Report to the Future Melbourne Committee**Agenda item 6.6****Planning Permit Application: TP-2022-474
82-84 Jolimont Street, East Melbourne****16 May 2023****Presenter:** Marjorie Kennedy, Head of Statutory Planning**Purpose and background**

PLANNING PERMIT APPLICATION DELEGATE REPORT

Planning permit application TP-2022-474 (**Application**) concerns the land at 82-84 Jolimont Street, East Melbourne (**Site**) which is formally identified as Land in Plan of Consolidation 100789.

Figure 25 – extract of the south elevation (Source: applicant)

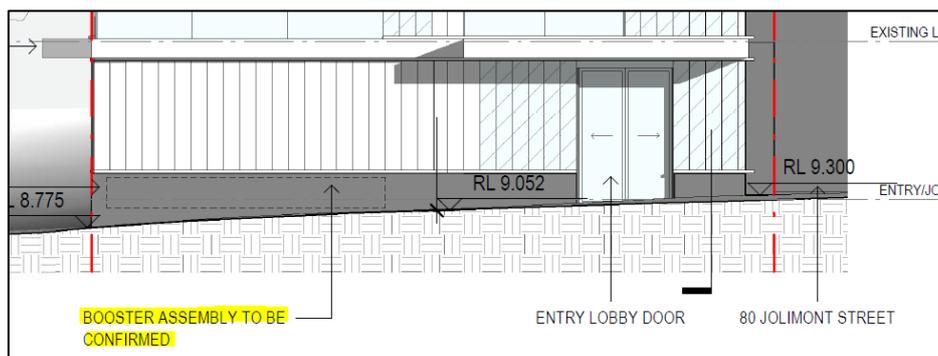
- **Booster assembly:** the booster assembly is proposed to be included within a plinth element to Jolimont Street – see figure 25 below. The current interface to Jolimont Street at this location is a rendered wall. This wall is proposed to be partially altered to 'GL02 – U GLASS: TRANSLUCENT TO SOLID BACKING'. This alteration is supported by the Urban Design department. The applicant has proposed that the final appearance of the booster plinth element be responded to via planning permit condition (should a planning permit issue), which is considered reasonable given the overall support for the ground floor interface. This is required as part of the Façade Strategy.

Figure 26 – extract of the west elevation (Source: applicant)

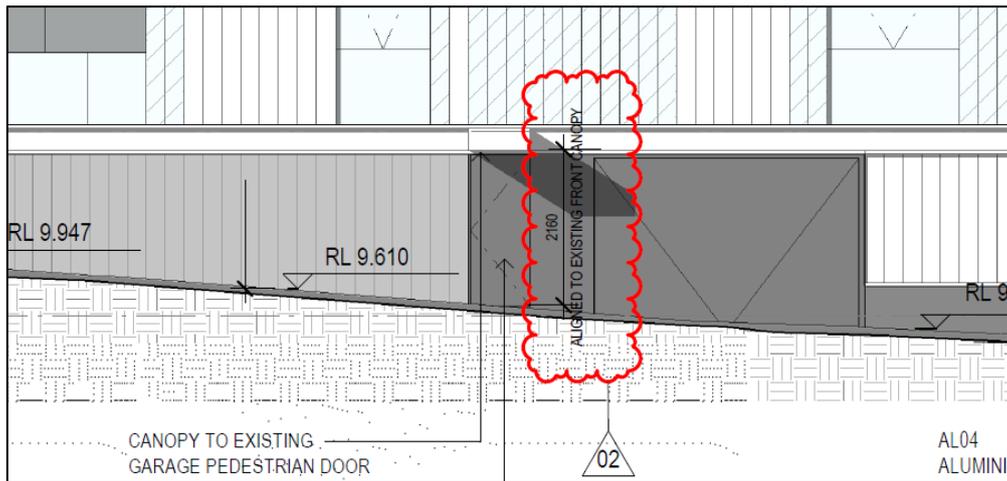
- The proposed canopy to Agnes Street (see figure 26 below) is a new proposed non-compliance with the REOG (a minimum of 2.7 m clearance to the footpath is required) and therefore is required to be removed by way of planning permit condition. This has been raised with the applicant who has agreed with this interpretation of the REOG.

- Being a potential non-compliance with the REOG, the applicant has confirmed that the garage door to Agnes Street will be designed such that it does not project beyond the title boundary when open, when closed, or when being opened or closed. A notation on the plans will be required by way of planning permit condition should a planning permit issue.

- b. Delete the ground floor pedestrian canopy to Agnes Street.
- c. Delete the note 'FLIGHT OF STAIR RISERS ABOVE 190 mm TO BE REVIEWED AS PART OF BAB APPLICATION' associated with the stair riser on drawing P10_000.

Figure 27 – extract of the north elevation (Source: applicant)

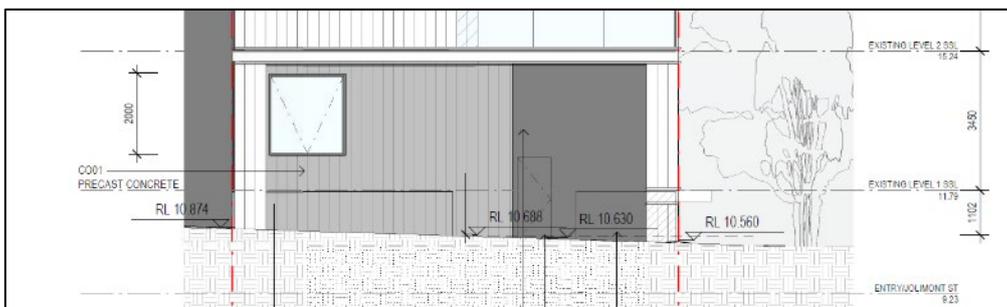
- Apartment 1 on Level 1 includes an outward opening kitchen window with a 300 mm encroachment into CL1859 – see figure 27 below. This is non-compliant with the REOG which require any encroachment to be a minimum of 5 m from the footpath / road level. The applicant has confirmed that the window can be made into a sashless window (i.e. operating upwards and downwards) with a 100 mm encroachment for weather protection purposes. Pursuant to the REOG, if there is no footpath then there can be no encroachments below 5 m. As such, the proposed 100 mm encroachment is unacceptable. A planning permit condition will be included to make this window a sashless window with no encroachment outside the title boundary, should a planning permit issue.

Figure 37 – marked up (dimensions added) version of P10_030 (proposed level 4 plan) (Source: applicant; dimensions added by Council)

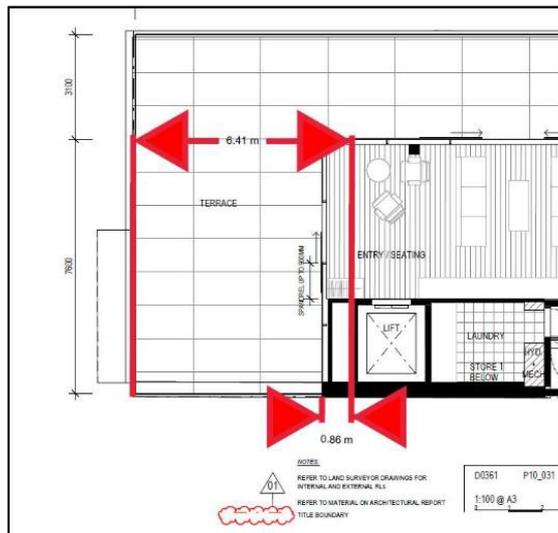
The applicant has confirmed that the area of shadow which falls outside of the existing shadow envelope is being created by the southern wall of the sitting area of the apartment at level 4. It would need to be relocated circa 0.86 m further north, to be in line with the existing lift shaft to be contained within the existing shadow envelope – see figure 37 below.

The applicant has submitted that a condition to contain the proposed shadow entirely within the existing envelope would be problematic for the proposed adaptive reuse of the building. The proposal seeks to use the existing lift shaft of the building, which is not compliant with the National Construction Code in its current form. The Council is informed that an appeal is currently underway with the Building Appeals Board (**BAB**) to allow the use of the existing shaft. Ultimately, if the appeal is not successful, the architect is of the view that they will be required then to provide a compliant lift shaft and as such will need the additional space to the south.

Whilst there is a minor encroachment outside of the existing envelope (maximum of 1.3sqm at June equinox), the proposal will result in a net decrease of shadow impact to the park compared to existing

Figure 41 – overlooking diagrams within the Urban Context Report (Source: applicant)

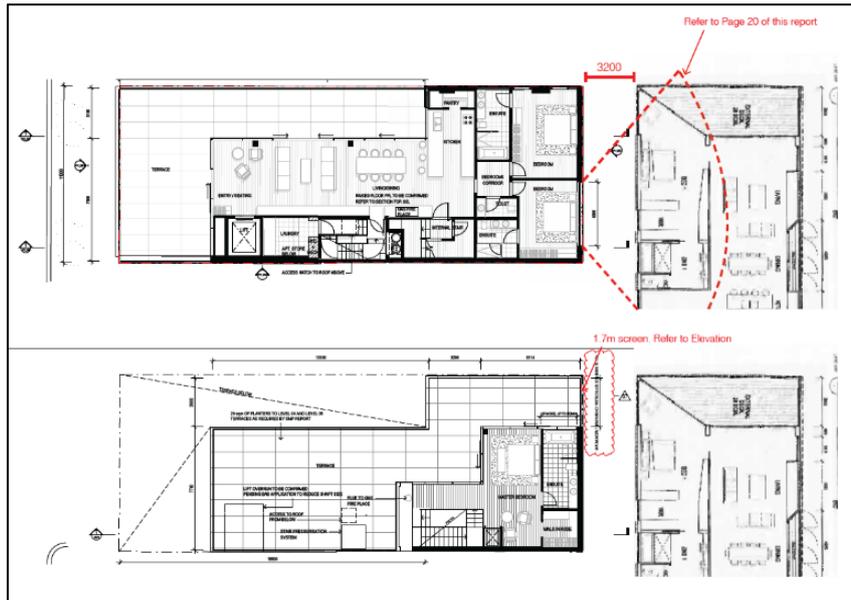
The proposed level 5 balcony includes 1.7 m screening with a maximum of 25% transparency which reasonably limits views. As such, there is no reasonable opportunity for overlooking from this terrace.

However, the level 4 'Bedroom' to the north east (see Figure 41 above) is not required to be screened given the existing overlooking conditions, it principally has views to non-habitable room windows, and the extent of overlooking to the secondary part to a bedroom is of such a miniscule amount.

On balance, it is considered that the Level 2 and 3 ‘North Terrace[s]’ are required to be screened in order to prevent unreasonable views to 16-18 Agnes Street. It is considered that it is appropriate to only screen the northern interface of these terraces given there is no unreasonable overlooking impact to the west. This maintains the daylight amenity to the habitable rooms that utilise windows to these terraces.

Figure 42 – photo of the south elevation of 16-18 Agnes Street (Source: Council)

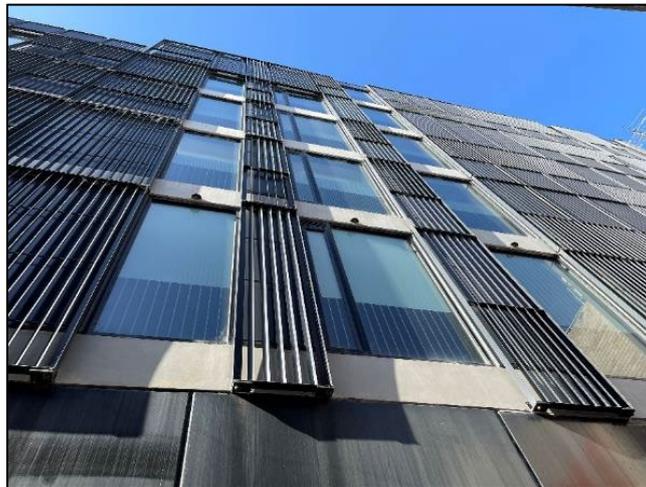
While views are possible into the other windows of 16-18 Agnes Street, as discussed above there are non-habitable windows which are not protected by the Planning Scheme. Notwithstanding this, as figure 42 below shows, some of these windows appear to be screened.
